SERVICE NO. 1375A BULLETIN

Date: November 29, 2022

**PERIODIC REPLACEMENT OF MAIN LANDING GEAR
ATTACHMENT HARDWARE**

SB 1375A adds a bolt hole inspection.

Figure 1
Main Landing Gear – Mounting Hardware

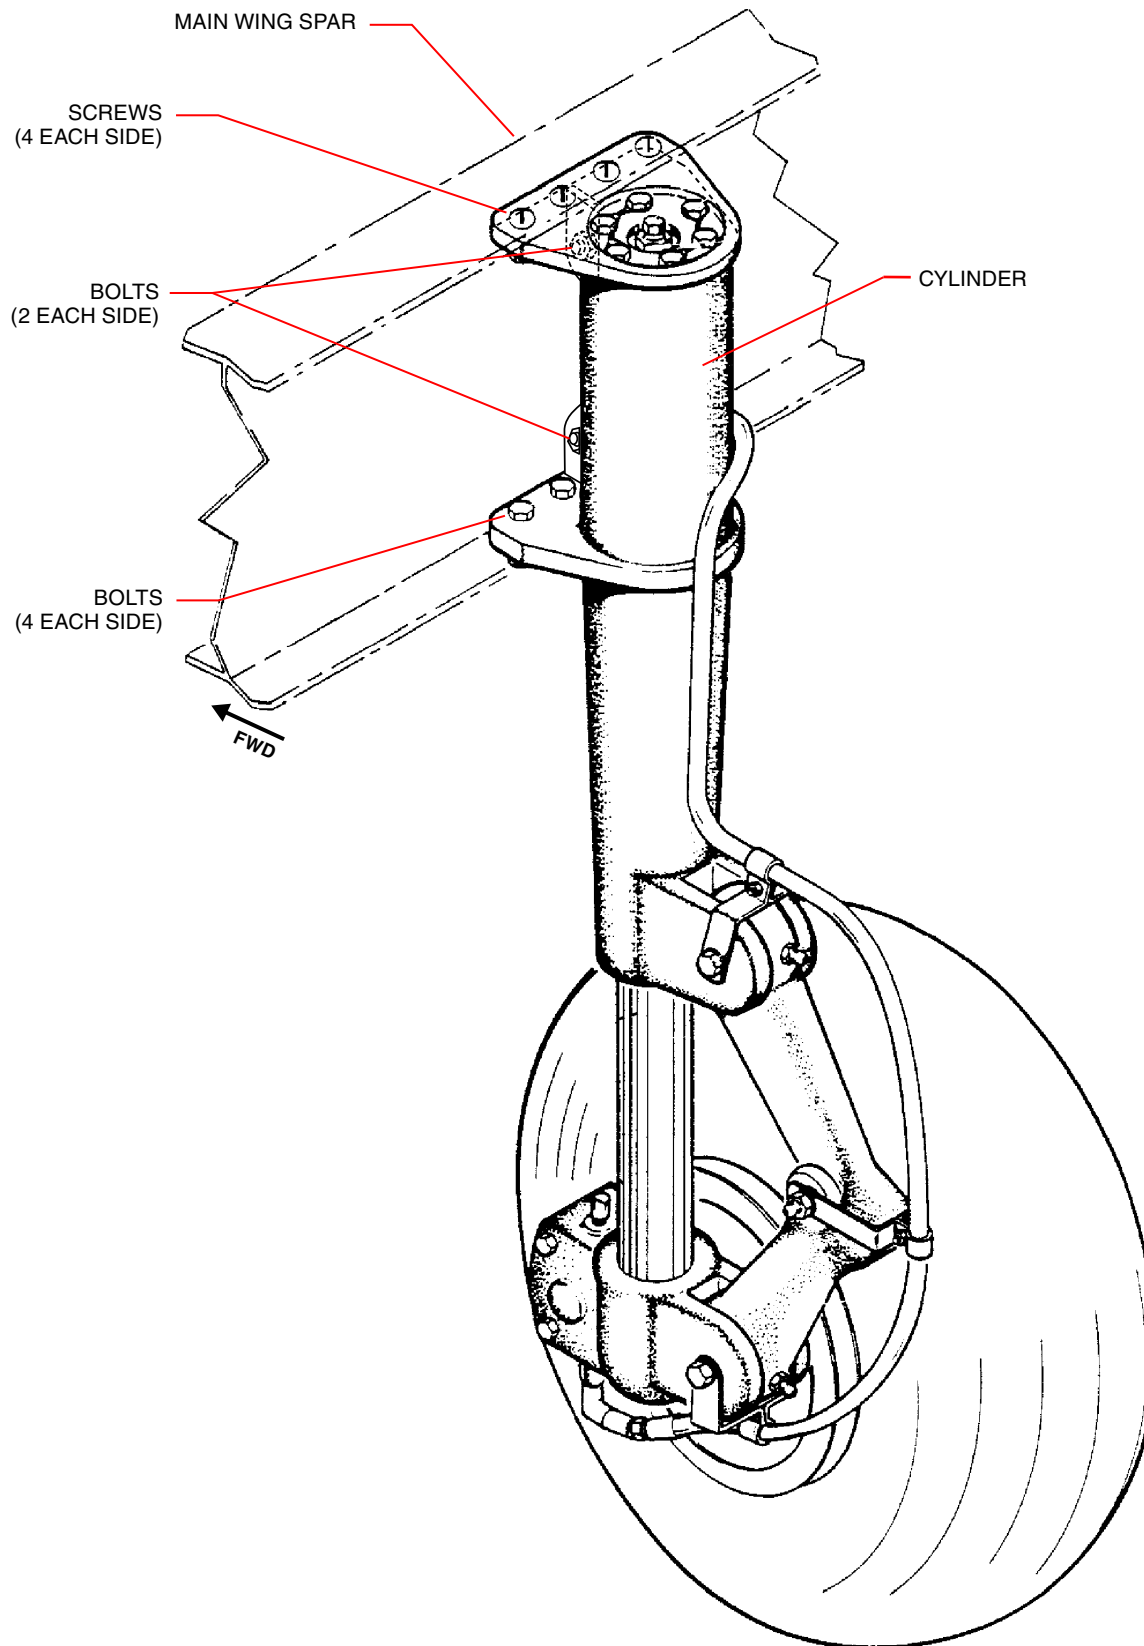
The main landing gear (MLG) are attached to the aircraft with threaded fasteners that pass through mounting flanges on the strut cylinder and the upper and lower flanges of the main wing spar, as depicted in the illustration below. On some of the affected aircraft, additional threaded fasteners pass through the web of the main wing spar.

1. Place the aircraft on jacks.
2. Remove the fairing from around the strut cylinder housing and the access plate located on the bottom of the wing and to the rear of the housing by removing attaching screws.
3. Remove and discard all of the threaded fastener stack ups (which includes screws and bolts, as well as nuts and washers) that attach the MLG to the main wing spar. (See "Figure 1" on page 5.)

- a. Measure the bolt holes common to the main wing spar and the landing gear cylinder (four holes through the lower spar flange and two through the spar web). Compare measured holes sizes against the acceptable maximum hole sizes shown in Table 1.
- If all bolt holes do not exceed the values shown in Table 1, then no modification is required. Proceed to Step 5.
 - If one or more bolt holes exceed the values shown in Table 1, it may be possible to replace the factory original hardware with a 1/64 or 1/32 oversize repair bolt. provided the minimum dimensional requirements as out-lined in 4 b. 1) and / or 4 b. 2) are complied with Proceed to Step 4. b.

- b. For replacement of factory original hardware with oversize repair bolts/screws (where applicable), refer to Table 2 for part numbers and hole sizes. Procure oversize repair bolts/screws locally. If the bolt/screw hole cannot be cleaned up within the tolerances specified in Table 1, some other repair is required.

- 1) For oversize holes in the spar web, measure the local thickness of the spar web near the affected bolt hole.
 - If the web thickness measures at least 0.0907, a 1/64 oversize bolt is permissible.
 - If the web thickness measures at least 0.0908, a 1/32 oversize bolt is permissible.
- 2) For oversize holes in the spar flange, measure the local thickness of the spar flange near the affected screw hole.

- If the flange thickness measures at least 0.2694, a 1/64 oversize repair screw is permissible.
- If the flange thickness measures at least 0.2713, a 1/32 oversize repair screw is permissible.

- if D does not exceed 0.2664, a 1/64 oversize repair screw is permissible;
- if D does not exceed 0.2820, a 1/32 oversize repair screw is permissible.
